AMENDMENT OF SOLICITATION / MODIFICATION OF CONTRACT		1. CONTRACT	PAGE 01	OF PAGES 25
2. AMENDMENT/MODIFICATION NO. 002	3. EFFECTIVE DATE 17 October 11	4. REQUISITION/PURCHASE REQ. NO.	5. PROJECT NO. (If applicable)	
6. ISSUED BY OFFICE OF PROCUREMENT P. O. BOX 653 LEONARDTOWN, MD 20650		7. ADMINISTERED BY (If other than item 6) OFFICE OF PROCUREMENT PO BOX 653 LEONARDTOWN, MD 20650

Pre-Bid Site Walk Question/Answer with Further Statements
 12-PSIT-61051- Amendment 002
 800 MHz Radio Communications Systems Procurement

UPS Designs

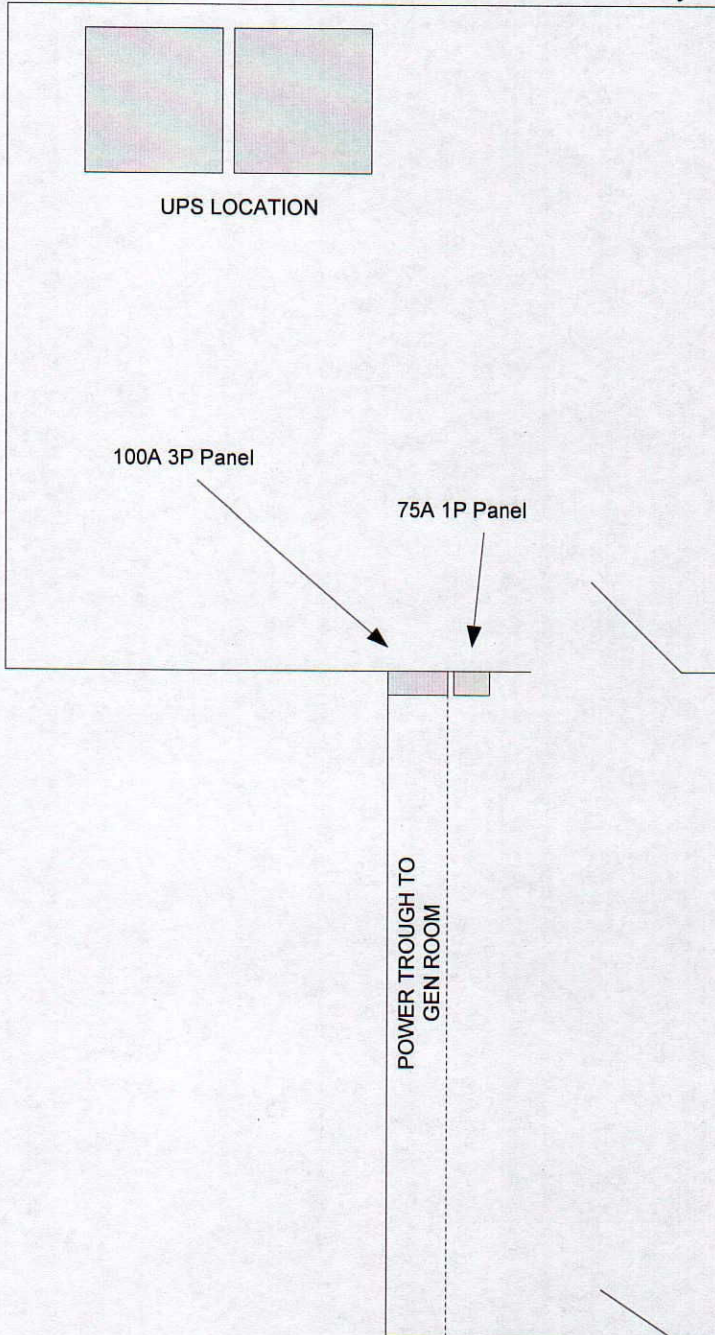
EOC Dispatch

There is no need for a new UPS in the EOC equipment room. The unit is a Comet MGE 72-160512-22 50 kVA 208 VAC 139A at 0.8 pf running at 30%. However, the UPS panel in the back room will require an expanded distribution panel which can be installed adjacent to the existing panel. The UPS panel has space for a subpanel breaker to feed the new panel.

Location just under two existing panels

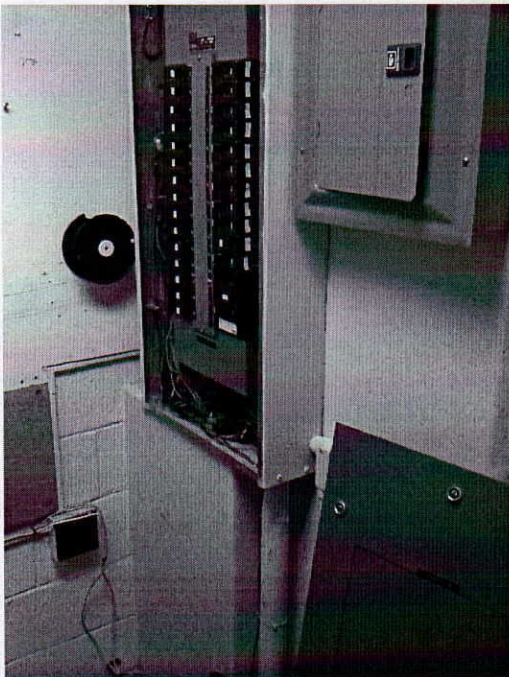
Back-Up Dispatch (Bunker)

A new three phase UPS will be required in the rear equipment room of the back-up dispatch center. The size required is a 20 kVA unit with 30 minutes run time at full load, double conversion, static bypass. The unit can be installed in the rear corner of the equipment room. A second battery cabinet will likely be required to reach the 30 minute run time requirement.

Shows 3P Panel B and load distribution panel

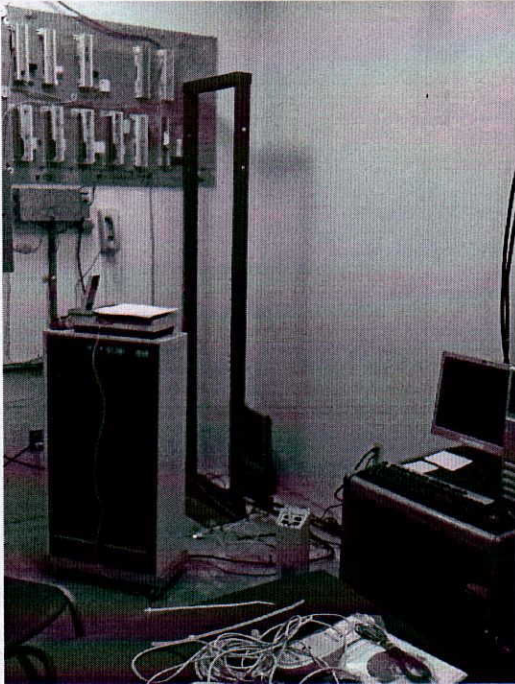
Corner for locating UPS unit(s)
